**FINAL**  
**Environmental Impact Report**  
**Warm Springs/South Fremont Community Plan**  
**City of Fremont, Alameda County California**

**State Clearinghouse No. 2013032062**

June 19, 2014

**Page 2-19, Exhibit 2-5**

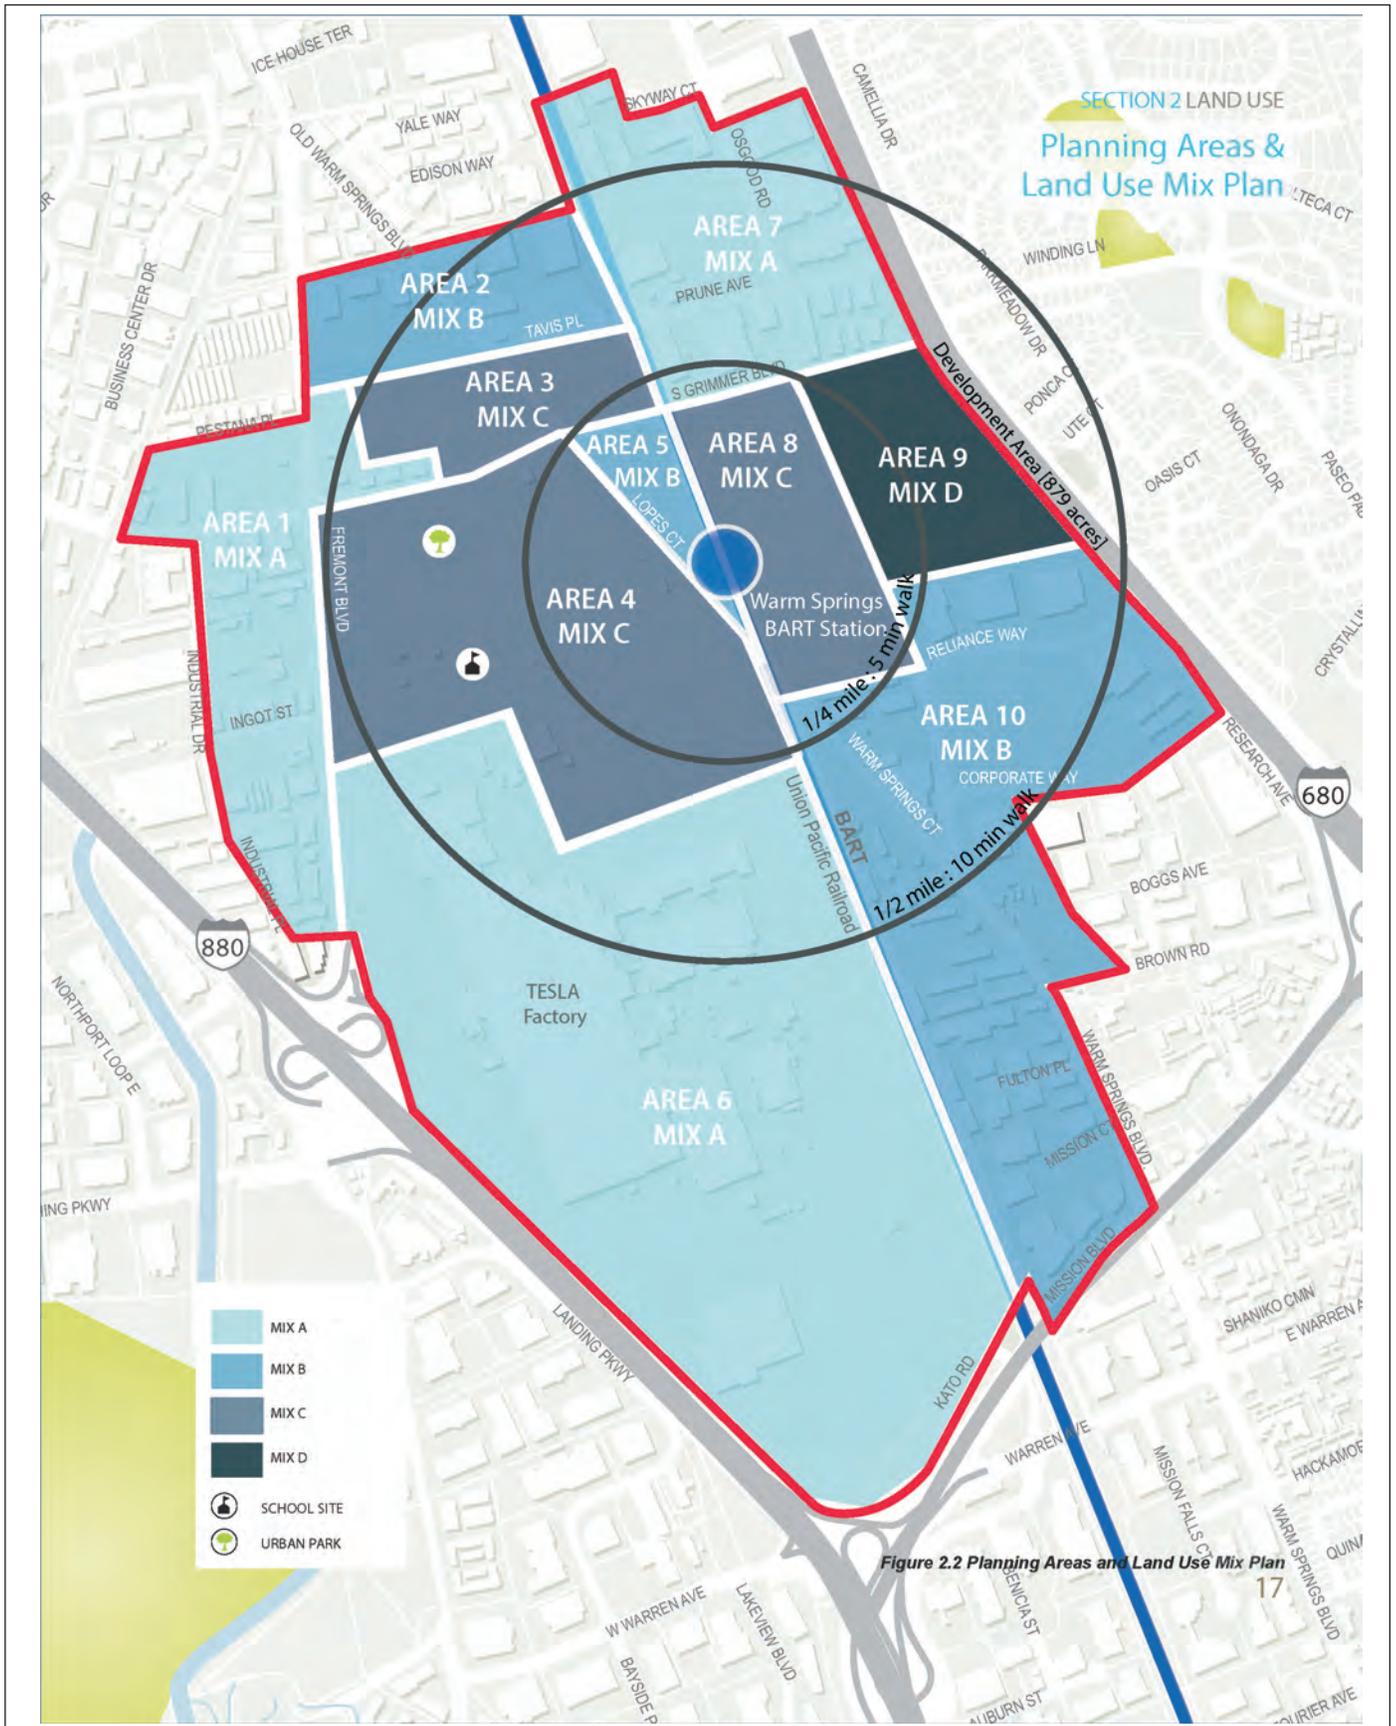
Page	Comment
2-18	The section "Parking Requirements" makes reference to Exhibit 2-5 and states that parking maximums are listed for each land use, but that information does not appear in Exhibit 2-5.
2-19	Exhibit 2-5 lists minimum density within ¼ mile of transit as 50 units/acre, and 30 units/acre outside of the ¼ mile radius. The WS/SF Community Plan and the DEIR both list lower minimum densities than shown in Exhibit 2-5 when the minimum densities are specified by individual Planning Area (see next comment for details). In the Community Plan document, this same exhibit appears on page 19 as Figure 2.3 Land Use Matrix, and the text notes that the minimum densities are established as set forth in Figure 2.3, when they are clearly different. This inconsistency should be resolved.
2-19	Similarly, Exhibit 2-5 lists FARs ranging from 0.35 (Industrial Land use) to 1.5 (Office and Convention). These ratios are too low and not representative of a Suburban Center Transit Oriented Development. The latter should have a minimum 4.0 FAR.

The agency noted that Exhibit 2-5 (Land Use Mix and Land Use Standards) lists minimum density within 0.25 mile of transit as 50 units/acre and lists 30 units/acre outside of the 0.25-mile radius. The agency stated that this is inconsistent with other statements in the Draft EIR and Community Plan that list lower densities and should be resolved.

The employment values in Table 2-4 correspond to the employment rates shown on Exhibit 2-5 (Land Use Mix and Land Use Standards). For hotel uses, an employment rate of one job/1,500 square feet was used. However, Exhibit 2-5 has been revised and now notes an estimated employment rate of 0.35 jobs per guest room, consistent with the author's comment (see Section 4 of this Final EIR). Also of note in Section 4 is that Table 3 and Table 4 have been combined.

Exhibit 2-5 has been revised to reflect changes to the Warm Springs/South Fremont Community Plan. The revised exhibit indicates that a school would be allowed within Mix C and hotel jobs are based on 0.35 employee per room.
